ECN/PCN No.: 4728

Product Description:
PLASTIC PACKAGE ULTRA MINIATURE
PURE SILICON™ CLOCK OSCILLATORS

Abraccon Part Number / Part Series:
ASFLMP

Mechanical Dimensions:

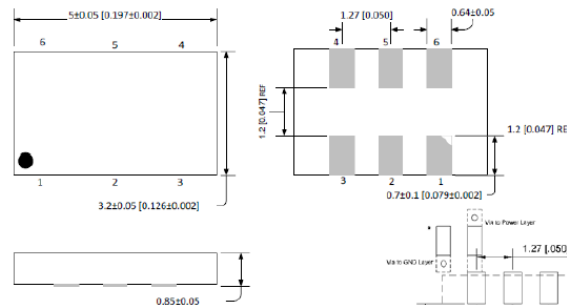
Revised mechanical dimensions to comply with existing product configuration. Removed power down function. Removed blank = tube option.

Tape and reel:

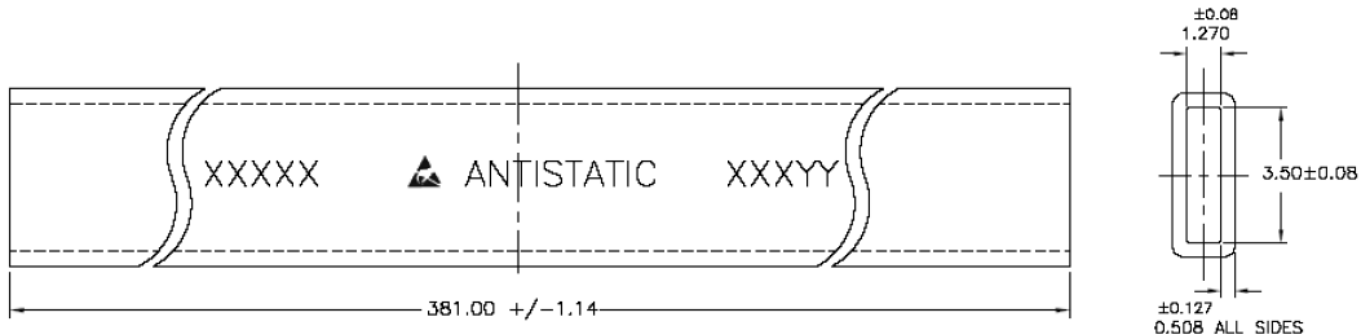
Tape and Reel: Removed tube option
